Technical Updates for Pool Professionals

October/2020

A Clearer Picture of the New Vent Kits

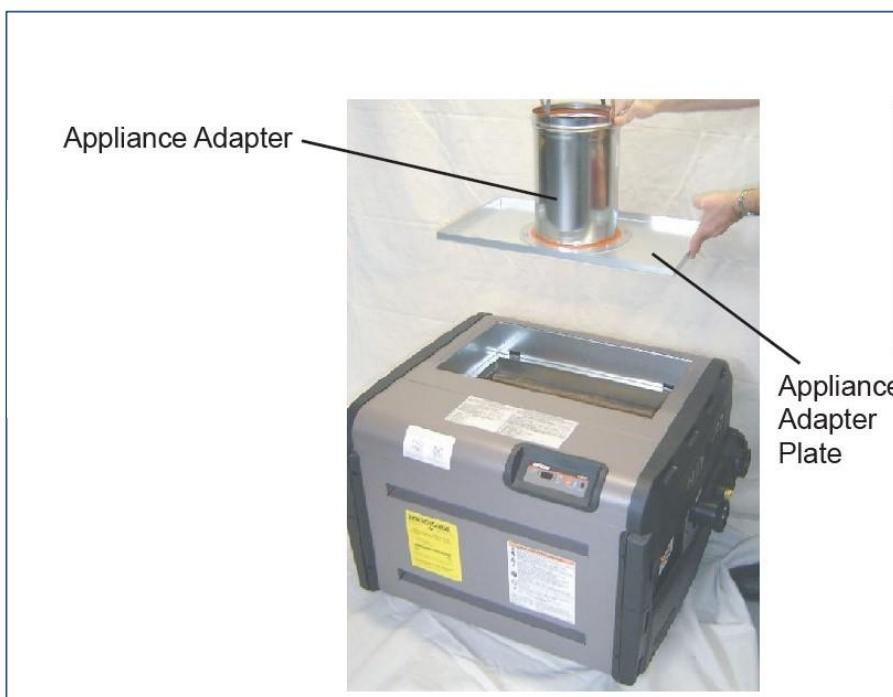
In October of last year we made a major change in our UHS heater and the associated Indoor Vent Kits.

1. Went to a solid top on the heaters
2. Changed all the vent kits so that the last digit of the kit part number indicated the size of the vent pipe needed

3. Removed the "Appliance Adapter" from Positive Pressure Vent Kits for heaters that were certified for smaller vent pipe.
 - a) H250 heaters with 4" vent pipe (**UHXPOSHZ12504**)

- b) H400 heaters with 6" vent pipe (**UHXPOSHZ14006**)
 - c) H500 heaters with 6" vent pipe (**UHXPOSHZ15006**)
 - ❖ For these three Positive Pressure Vent Kits an Appliance Adapter will have to be purchased separately and the installer will have to purchase the adapter that matches the type of vent pipe they are using for the installation (DuraVent, or HeatFab).

4. All other positive pressure vent kits come with a HeatFab Appliance Adapter in the box, but they are not certified for use with DuraVent vent pipe.
5. All Negative Pressure Indoor Vent Kits come with the appliance adapter in the box.

New (HL-BASE) MSP LCD

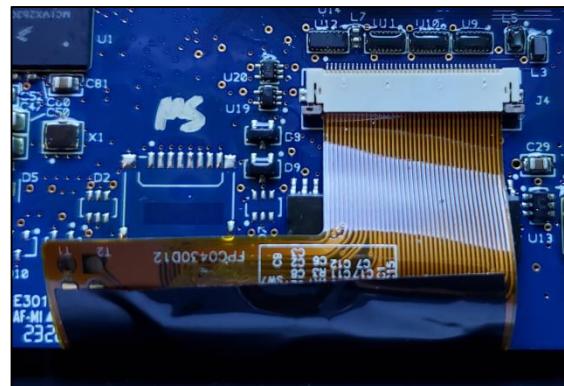
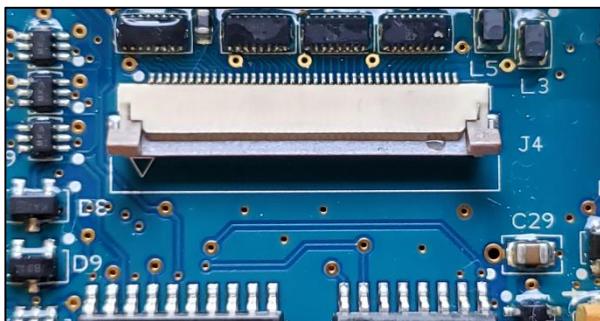
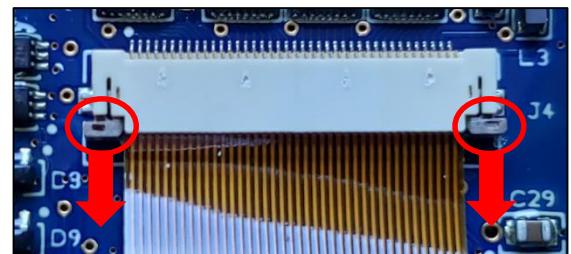
A change has been made to the OmniLogic's (HL-Base) LCD. We have switched to a new manufacturer for the LCD in the HL-Base MSP. The part number for the new LCD is **HLX-LCD0520**.

- If the HL-Base was manufactured prior to May 14, 2020 continue to use **HLX-LCD** for a replacement LCD screen.
- HL-Base manufactured after May 14, 2020 will have the new LCD screen with part number **HLX-LCD0520**. If a replacement LCD is needed, use only **HLX-LCD0520**.
- HLX-LCD0520 is not backwards compatible with units manufactured prior to May 14, 2020.
- HLX-LCD cannot be installed in MSPs manufactured after May 14, 2020.
- The connector for the LCD's ribbon cable has changed. See the photos below to learn how to disconnect the ribbon cable.

To remove the ribbon cable, lift up the two tabs on both ends. This will loosen the ribbon cable so it can be pulled out.

To remove the ribbon cable, pull down on the two tabs on both ends. This will loosen the ribbon cable so it can be pulled out.
